# UNITED STATES PATENT AND TRADEMARK OFFICE

APPLICATION NO.	FILING DATE	FIRST NAMED INVENTOR	ATTORNEY DOCKET NO.	CONFIRMATION NO.
09/762,473	02/07/2001	Ofer Du-Nour	1639/14	4653

## Office Action Summary

### **Office Action**

FIG. 3

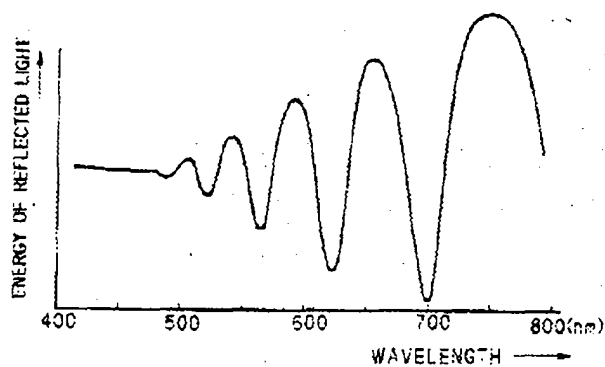
Kondo teaches an apparatus for measuring film thickness comprising a broadband light source(10) for illuminating a film, imaging optics(18), film(S), spectroscopic unit(32) which detects the intensity of the light reflected from the film(figure 4) and produces a signal defining the intensity variations(figure 3), and processor(34) which determines the thickness of the film based on the different frequencies of the signal. See figure 6.

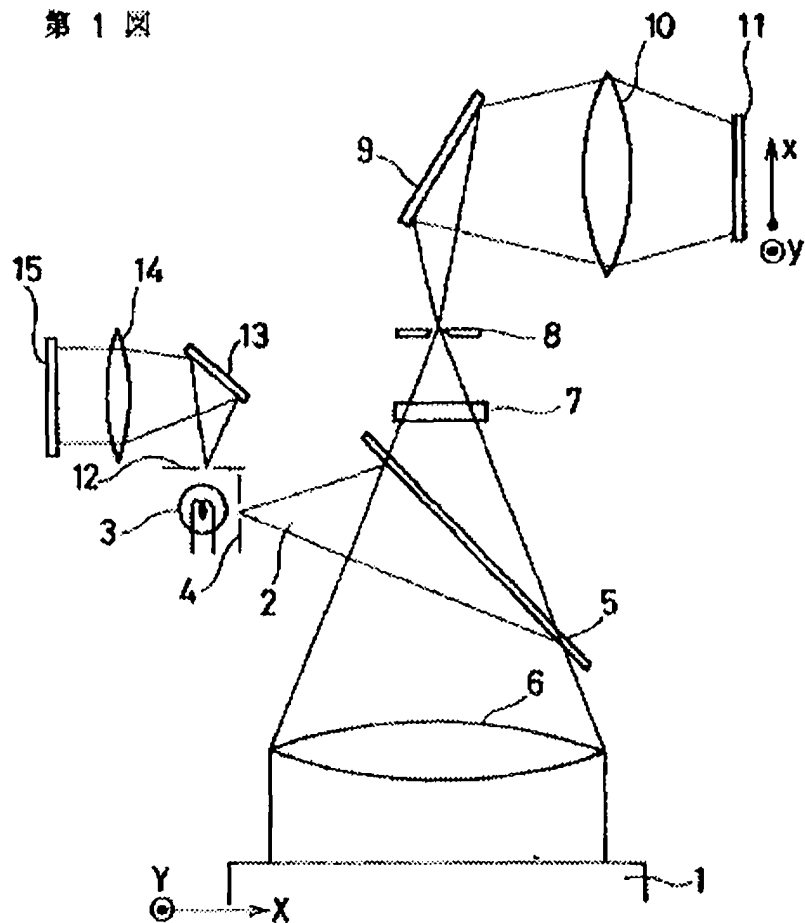
Masayuki et al teaches an alterative spectroscopic analyzer which includes a stationary grating(9), and an array of detectors(11) which provides a detector for each frequency.

It would have been obvious to one of ordinary skill in the art at the time the invention was made to use the spectroscopic arrangement of Masayuki over that of Kondo because all frequencies are detected simultaneously with the detector array.
